Safety Evaluation Report

related to the operation of
San Onofre Nuclear Generating Station,
Units 2 and 3

Docket Nos. 50-361 and 50-362

February 1981

Figure 361.45 - 1 Empirical Plot
Geologic Slip Rate VS Historical
Magnitude for Strike-Slip Faults

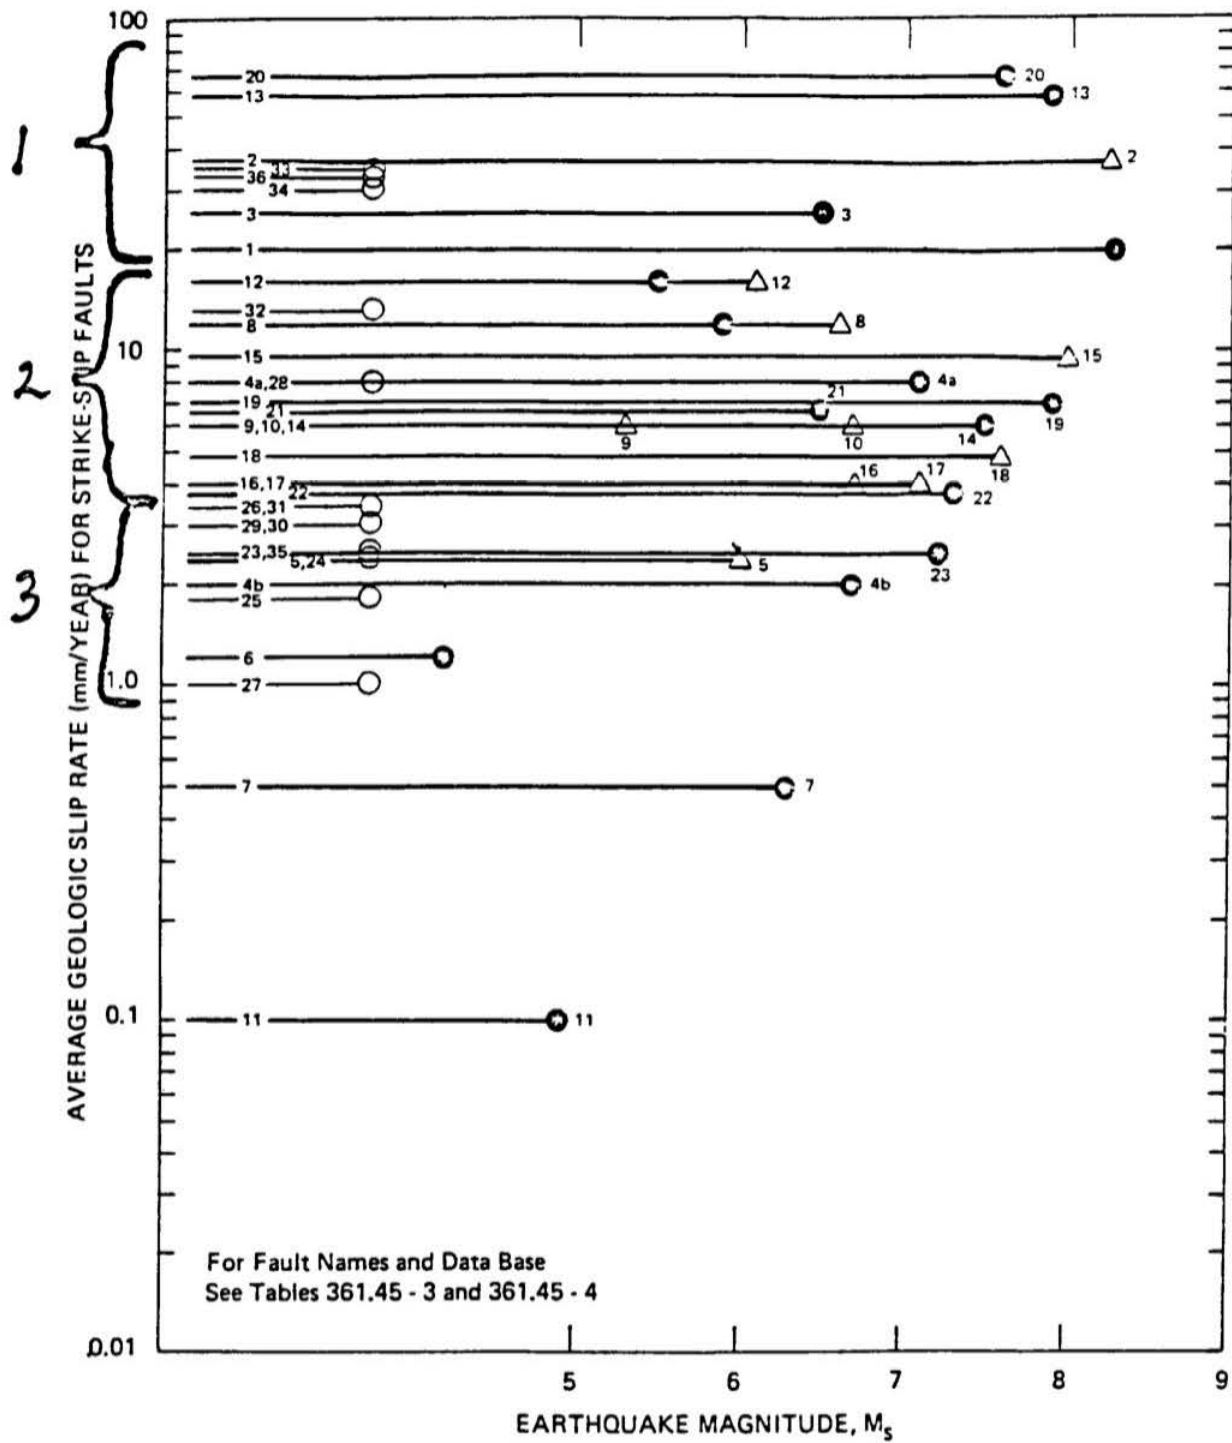
However, in an effort to be responsive to your requests to review the material submitted by the applicant, we offer the following comments concerning the primary technique discussed by the applicant, slip-rate versus magnitude study.

On the question of the statistical significance of the slope of a line bounding points on the log slip-rate versus magnitude plot, the applicant's consultants point out that while a single fault with low slip-rate is unlikely to have a "maximum" earthquake in historic time, a group of low-slip-rate faults has a significance proportional to their moment-rate sum. This same reasoning can be applied quantitatively.
